VERMONT YANKEE NUCLEAR POWER CORPORATION

May 23, 2000
BVY 00-48

**Subject: Vermont Yankee Nuclear Power Station
License No. DPR-28 (Docket No. 50-271)
Technical Specification Proposed Change No. 234
Reactor Coolant Chemistry – Conductivity and Chlorides**

Proposed Technical Specification Change No. 234

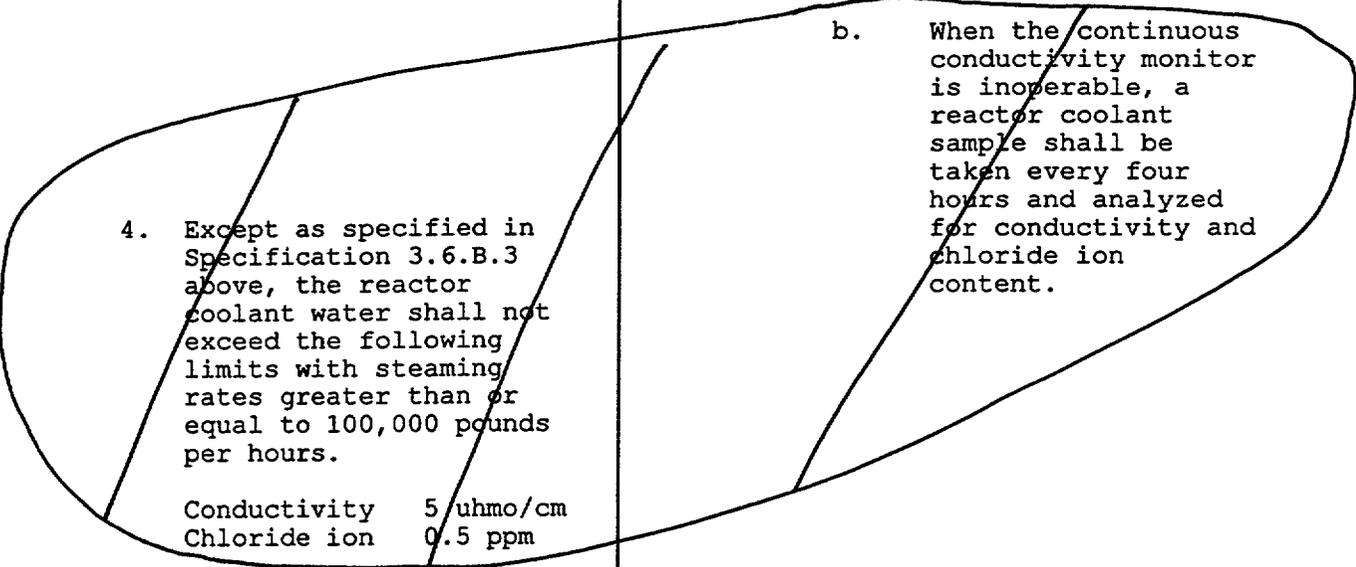
The current requirements stipulated by Specifications 3/4.6.B.2, 3/4.6.B.3 and 3.6.B.4 will be relocated to the TRM, and 3.6.B.5 will be repeated in the TRM as applicable to these relocated Specifications. Because of the relocation of the above TS sections, as an administrative change, TS 3.6.B.5 will be renumbered to 3.6.B.2. In addition, minor reformatting and capitalization changes are being made to correct administrative errors. The associated Bases will also be relocated to the TRM, and a single word correction is being made in Bases Section 3/4.6.C.

2. The reactor coolant water shall not exceed the following limits with steaming rates less than 100,000 pounds per hour except as specified in Specification 3.6.B.3:

Conductivity	5umho/cm
Chloride ion	0.1 ppm

3. For reactor startups the maximum value for conductivity shall not exceed 10 umho/cm and the maximum value for chloride ion concentration shall not exceed 0.1 ppm, in the reactor coolant water for the first 24 hours after placing the reactor in the power operating condition.
